Access Compliance Report Public Rights-of-Way (Curb Ramps)

Main Street: NARROW_CANYON_RD		Cross Street: CLARIN_ST		Location:	S
ADA ID: RPRK211028140750	Ramp Type:Type 1 - Perpendicular	Initial Pass/Fail: Fail	Overall Compliance: No	Severity Score:	16

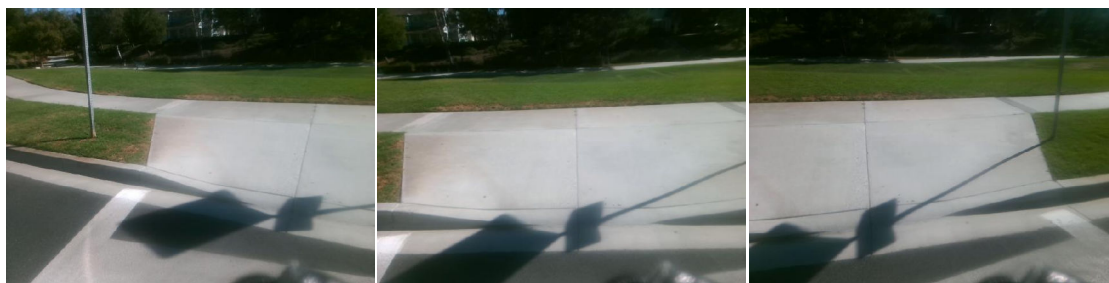
R304.2.2, R204.3, R304.5.3, STD 1115

Remove & Replace Entire Ramp.
